Access Compliance Report Public Rights-of-Way (Curb Ramps)

Intersection ID: 12721 Main Street: S_CHURCH_ST Cross Street: W_HILL_ST Location: S

ADA ID: 3D4A80B76B50 Ramp Type: Perp Initial Pass/Fail: Pass Overall Compliance: No Severity Score: 12.5

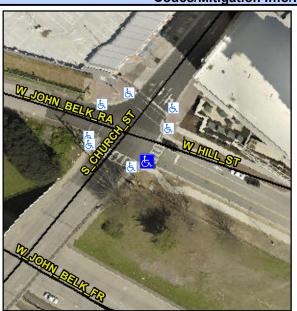
Field Measurements/Component Compliance					
Compliance Description		Data	Compliance Description		Data
N/A	Ramp Length (in)	72.0	Yes	Ramp Slope (%)	6.7
Yes	Ramp Width (in)	60.0	Yes	Ramp XSlope (%)	2.0
N/A	Flare Type LT	Sloped	N/A	Flare Type RT	N/A
N/A	Flare Slope LT (%)	3.2	No	Flare Slope RT (%)	10.2
N/A	Flare Traversable LT?	Yes	N/A	Flare Traversable RT?	Yes
No	Landing Length (in)	N/A	Yes	DWS Provided?	Yes
No	Landing Width (in)	N/A	Yes	DWS Contrast?	Yes
No	Landing Slope (%)	N/A	Yes	DWS Length (in)	24.0
No	Landing X Slope (%)	N/A	Yes	DWS Full Width?	Yes
N/A	Landing Curb? (Y/N)	No	No	DWS Offset (in)	3.0
N/A	Shared Landing?	No			
Yes	Gutter Ponding?	No	Yes	Gutter Slope (%)	2.3
Yes	Gutter Lip Ht (in)	0.0	No	Gutter X Slope (%)	2.7
N/A	Painted X Walk1?	Yes	N/A	Painted X Walk2?	N/A
	X Walk 1 Direction	To NE		X Walk 2 Direction	N/A
N/A	X Walk 1 Width (in)	109.0	N/A	X Walk 2 Width (in)	N/A
	X Walk 1 Slope (%)	0.9		X Walk 2 Slope (%)	N/A

X Walk 1 X Slope (%)	2.5		X Walk 2 X Slope (%)	N/A
Yes	Ramp inside XWalk1?	Yes	N/A	Ramp inside XWalk2?	N/A
	Road Slope (%)	N/A	N/A	Clear Space?	Yes
	Road X Slope (%)	N/A	N/A	Clear Space to XWalk (in)	N/A
Yes	Any Obstructions?	No	Yes	Storm Grate/Utility Hazard?	No
	Obstruction Type			Storm Grate/Utility Type	
		N/A			N/A
			Yes	Surface Condition? (G/P)	Good

Remove & Replace Entire Ramp.
Remove & Replace Gutter.

R304.2.1, R304.2.2-Perp, R304.3.2-Para, R304.5.3, R304.2.3, R305.2
